SAN FRANCISCO PLANNING DEPARTMENT

MINOR PROJECT MODIFICATION

Minor Project Modification Number: 001 **Date:** 5/28/2020

Project Title: Moccasin Powerhouse Rehabilitation

Area Map: Moccasin Powerhouse, existing GSUTs, and yard. Approximate excavation area for secondary containment shown in yellow. Numbered photo points.

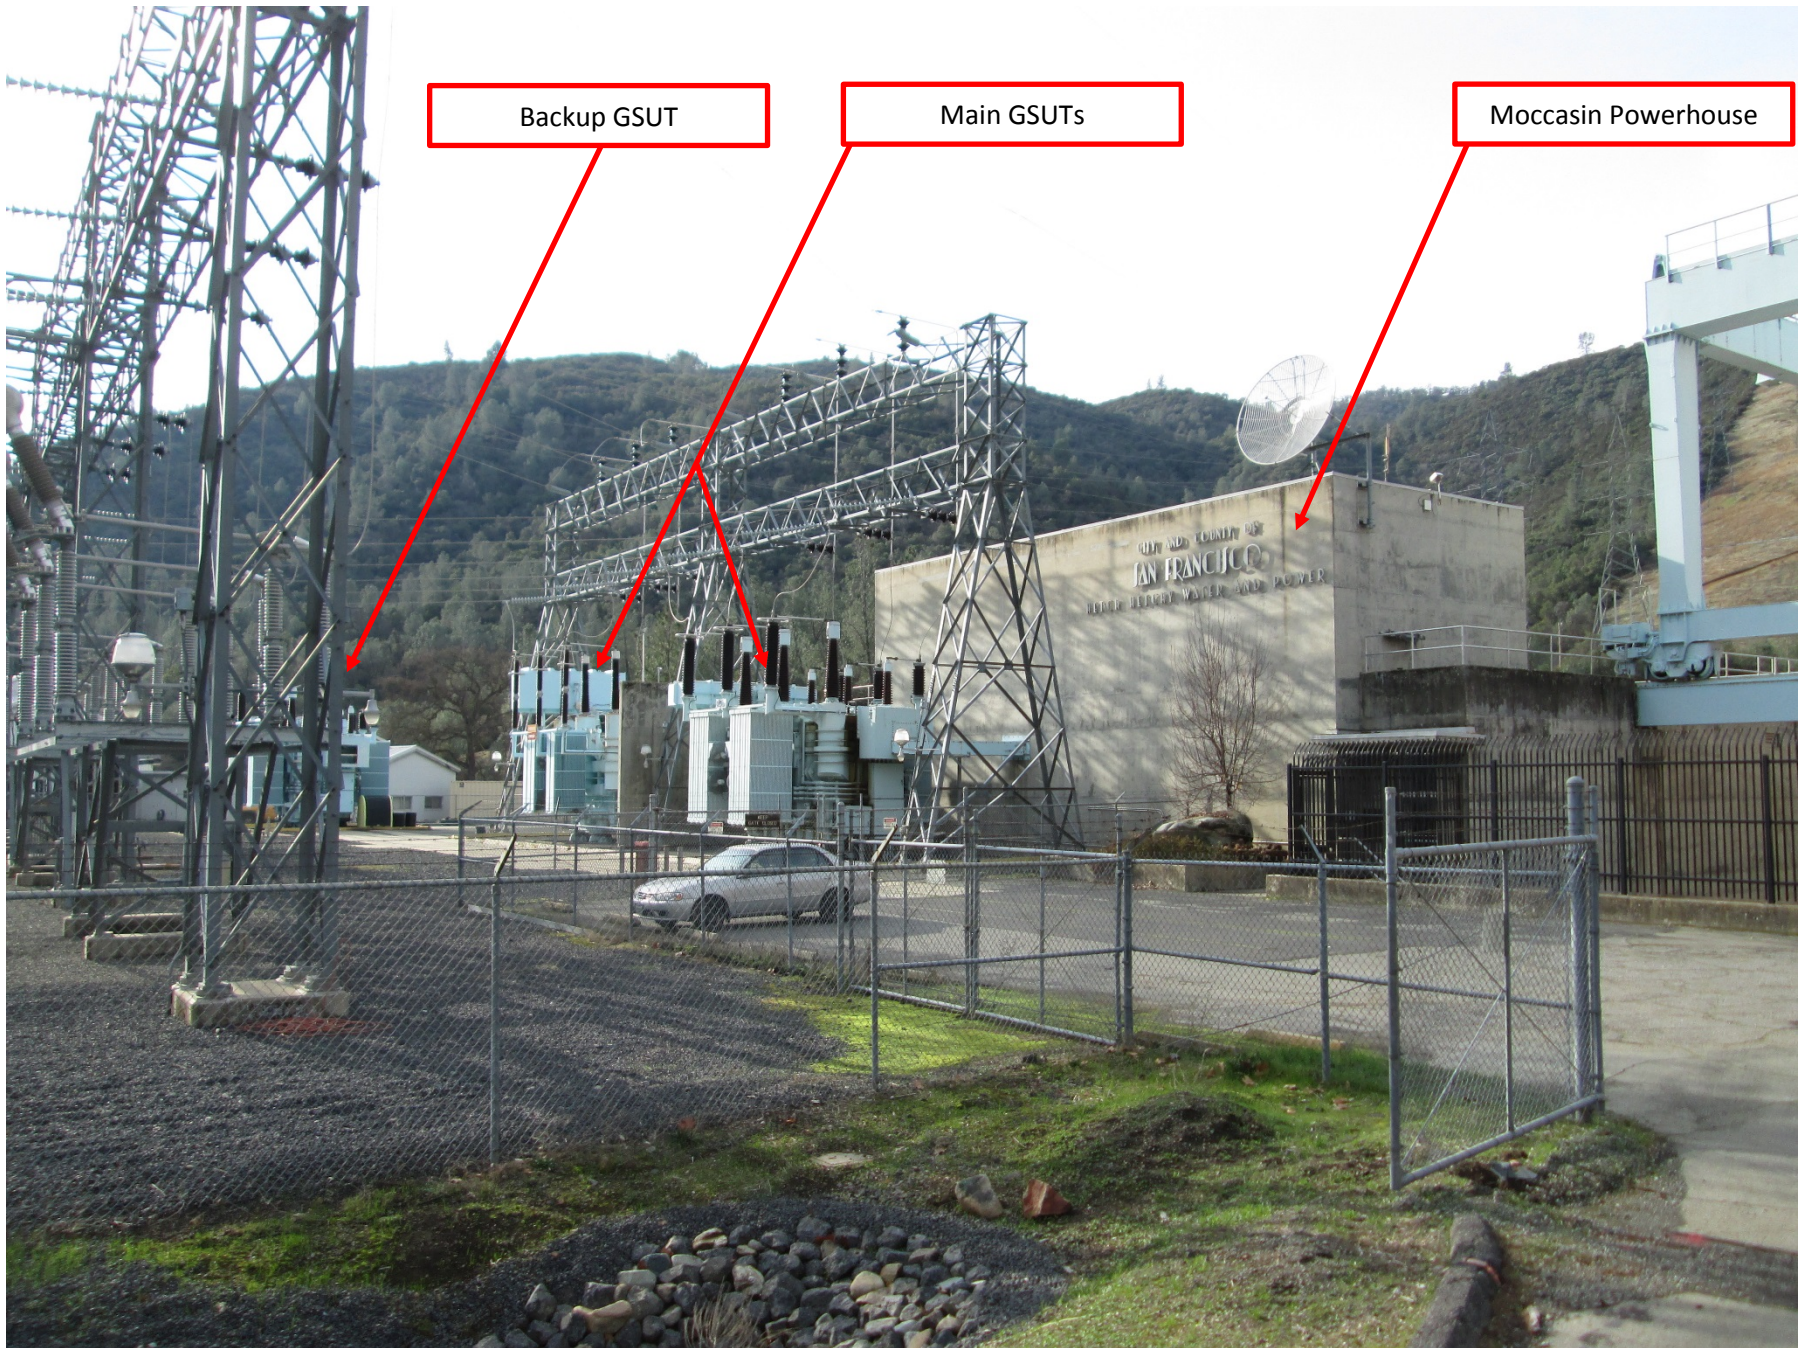
To meet current standards and regulations, secondary containment units underneath each main GSUT would be improved and connected to the existing MPH oily water separator system. Two areas approximately 35-feet wide, 35-feet long, and 7-feet deep would be excavated along with some adjacent minor trenching for replacement electrical grounding for the GSUTs. The existing concrete fire wall between the two GSUTs would also be extended horizontally by approximately 6 feet.
